PIC16C773 Rev. A Silicon Errata Sheet

The PIC16C773 (Rev. A) parts you have received conform functionally to the Device Data Sheet (DS30275A), except for the anomalies described below.

FIGURE 1: $\overline{\text{MCLR}}$ EXTERNAL CIRCUIT

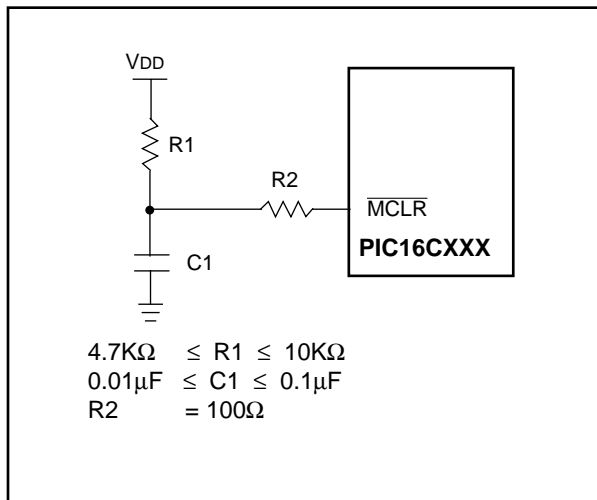
1. Module: RESET

The minimum specification for the $\overline{\text{MCLR}}$ must be met in order to RESET the PIC16CXXX. If a $\overline{\text{MCLR}}$ pulse occurs that is less than the minimum specification (parameter #30), improper device operation can occur.

If the Minimum specification cannot be met, then an external circuit must be used to insure that any pulse width less than the specification will be filtered before it reaches the $\overline{\text{MCLR}}$ pin.

A possible circuit is shown in Figure 1. Proper design validation needs to be done to ensure desired operation over the applications operating conditions

Figure 1: Wake-up from Sleep

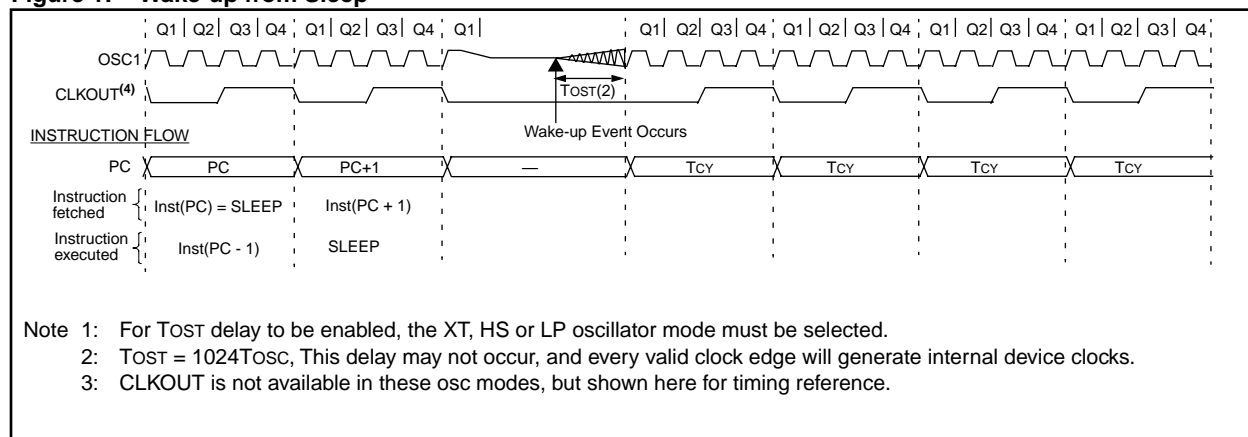
2. Module: OSCILLATOR

The Oscillator Start-up Timer (TOST) delay may not occur when the device wakes-up from sleep.

Figure 1 shows the start-up of the crystal after the event that causes the device to wake up from sleep mode (as specified in device data sheet). The start-up time (TOST) may not occur.

In applications where time based measurements are started immediately after wake-up from sleep, the suggested work around should be implemented.

After the SLEEP instruction, do a software delay of 256 Tcy (same as 1024 TOSC). At the Reset and Interrupt vector addresses, test to see if the device woke from sleep (the $\overline{\text{TO}}$ and $\overline{\text{PD}}$ bits), and if the device did wake from sleep, ensure that the total cycle delay is 256 Tcy.
